RE: Agreement No. 1946F
Traffic Impact Study Services
Task No. 5A Subtask 18A – Cedar Creek Station (aka Enclave at Starwood)

McCormick Taylor has completed its review of the Traffic Impact Study (TIS) for the Cedar Creek Station (aka Enclave at Starwood) development prepared by Bowman Consulting Group, Ltd., dated November 1, 2024. Bowman prepared the report in a manner generally consistent with DelDOT's Development Coordination Manual.

Scope of Improvements Figure
Cedar Creek Station (fka Enclave at Starwood) TIS

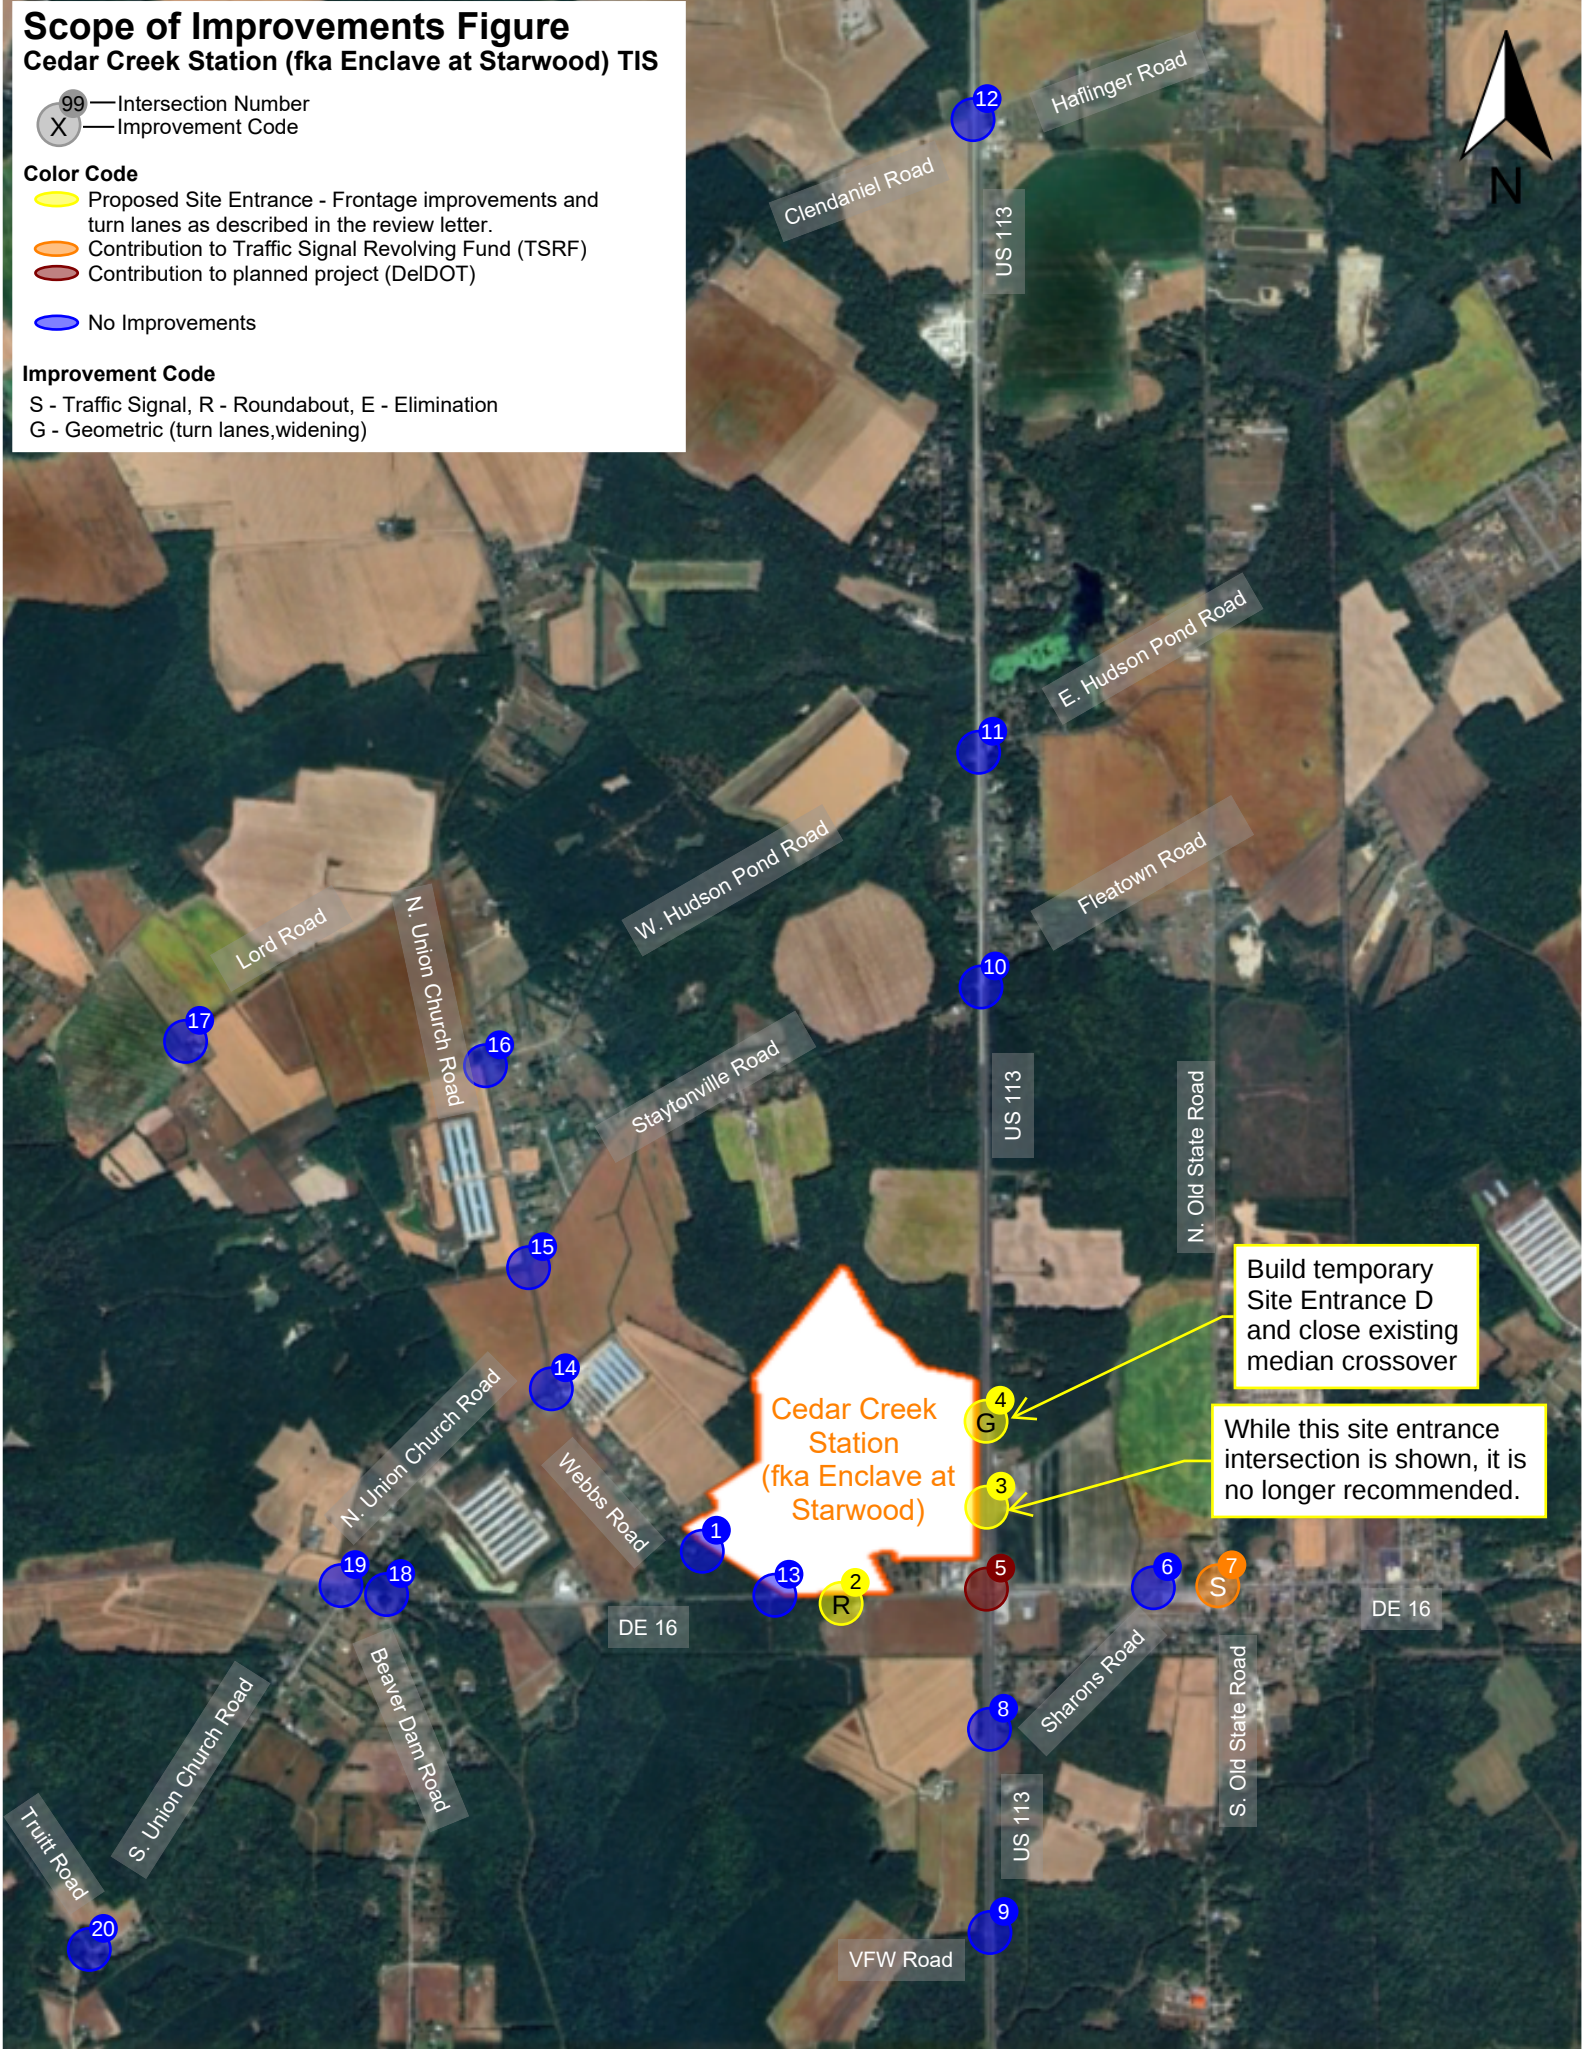
The proposed Site entrance C right-in/right-out entrance onto US Route 113 would operate at acceptable LOS during all peak hours under future condition with the proposed development. However, the proposed site is located within an Investment Level 2 area, and per the CCPP, direct access may be permitted along US Route 113 if providing access to only Delaware Route 16 would degrade operations and capacity at the US Route 113 and Delaware Route 16 intersection. To limit the interruptions to the flow of traffic in this CCPP corridor, DelDOT recommends that direct access on US Route 113 be limited to one location. As such, the proposed Site Entrance C on US Route 113 should not be constructed.

This unsignalized site entrance intersection experiences LOS deficiencies in Case 3 on the northbound US Route 113 U-turn at Site Entrance D. In Case 3 during the Saturday peak hour the northbound U-turn is expected to operate at LOS F with 51 seconds of delay. The developer is not proposing any improvements to mitigate this LOS deficiency. Acceptable LOS can be achieved by closing the existing median crossover located approximately 2,000 feet north of the existing intersection of US Route 113 and Delaware Route 16, and diverting the northbound U-turns to the existing median crossover located approximately 1,800 feet north of future Site Entrance D. As such, the developer should design and construct the closure of the existing median crossover,

This signalized intersection experiences LOS deficiencies in Case 2 during the Saturday peak hour and in Case 3 during the AM, PM, and Saturday peaks. In Case 2 during the Saturday peak the intersection is expected to operate at LOS E with 74 seconds of delay. In Case 3 during the Saturday peak hour the intersection is expected to operate at LOS F with 149 seconds of delay with queues over 850 feet long for the northbound left-turn and 820 feet long for the eastbound left-turn. Both of these queues are significantly longer than the existing turn lanes. However, mitigation improvements are not recommended at the intersection due to the overall changes to the roadway network as part of the *US 113 at SR 16 (Ellendale) Grade Separated Intersection* project which proposes a Grade Separated Intersection (GSI) at this location which would mitigate this LOS deficiencies. The project has not started design and the completion date is unknown at this time. It is recommended that the developer make an equitable share contribution to the *US 113 at SR 16 (Ellendale) Grade Separated Intersection* project.

This unsignalized intersection experiences LOS deficiencies in Case 2 and 3 during the AM, PM, and Saturday peaks. In Case 2 during the Saturday peak the southbound approach is expected to operate at LOS F with 590 seconds of delay. In Case 3 during the Saturday peak the southbound approach is expected to operate at LOS F with 1,366 seconds of delay. A traffic signal will mitigate these deficiencies. With a traffic signal, the intersection is expected to operate at LOS B in Cases 2 and 3 during the AM, PM, and Saturday peaks. A Traffic Signal Justification Study (TSJS) was previously completed by McCormick Taylor and approved by DelDOT. Other developers of pending developments in the area have been asked to contribute to or construct a traffic signal at this intersection. As such, the Cedar Creek Station (aka Enclave at Starwood) developer should make an equitable share contribution to the Traffic Signal Revolving Fund (TSRF).

1. The developer shall improve Delaware Route 16 within the limits of their frontage. The improvements shall include both directions of travel, regardless of whether the developer's lands are on one or both sides of the road. "Frontage" means the length along the state right-of-way of a single property tract where an entrance is proposed or required. If a single property tract has frontage along multiple roadways, any segment of roadway including an entrance shall be improved to meet DelDOT's Functional Classification criteria as found in Section 1.1 of the Development Coordination Manual and elsewhere therein, and/or improvements established in the Traffic Operational Analysis and/or Traffic Impact Study. "Secondary Frontage" means the length along the state right-of-way of a single property tract where no entrance is proposed or required. The segment of roadway may be upgraded by improving the pavement condition of the existing roadway width. The Pavement Management Section and Subdivision Section will determine the requirements to improve the pavement condition.

2. The developer should construct the roundabout Site Entrance B on Delaware Route 16. The proposed configuration is shown in the table below.

At the proposed Site Entrance B intersection, the developer should design and construct a single lane roundabout. Pedestrian crossings and bicycle lanes should be provided on all approaches to the roundabout. The developer should coordinate with DelDOT's Development Coordination Section to determine other design details during the site plan review.

- The developer should construct the temporary right-in/right-out Site Entrance D on US Route 113 at a point approximately 2,000 feet north of its existing intersection with Delaware Route 16. The proposed configuration is shown in the table below.

At the proposed Site Entrance D intersection, a southbound right-turn lane is warranted on US Route 113 based on DelDOT's Auxiliary Lane Worksheet. Initial recommended minimum turn lane length (excluding taper) is a 365-foot right-turn lane on southbound US Route 113. Additionally, the developer should design and construct a southbound auxiliary acceleration lane for vehicles exiting the site and merging onto US Route 113 southbound. The acceleration lane should extend from Site Entrance D to the existing right-turn lane for the Royal Farms on the northwest corner of the intersection of US Route 113 and Delaware Route 16. The developer should coordinate with DelDOT's Development Coordination and Traffic Sections to determine final turn lane lengths and other design details during the site plan review.

- The developer should design and construct the closure of the existing median crossover, including the northbound U-turn lane and the southbound U-turn lane, located on US Route 113 approximately 2,000 feet north of its existing intersection with Delaware Route 16. The developer should coordinate with DelDOT's Traffic and Development Coordination Sections to determine final design details during the site plan review, but this would include completely removing any existing pavement and modifying the existing striping along US Route 113 to accommodate the closures.
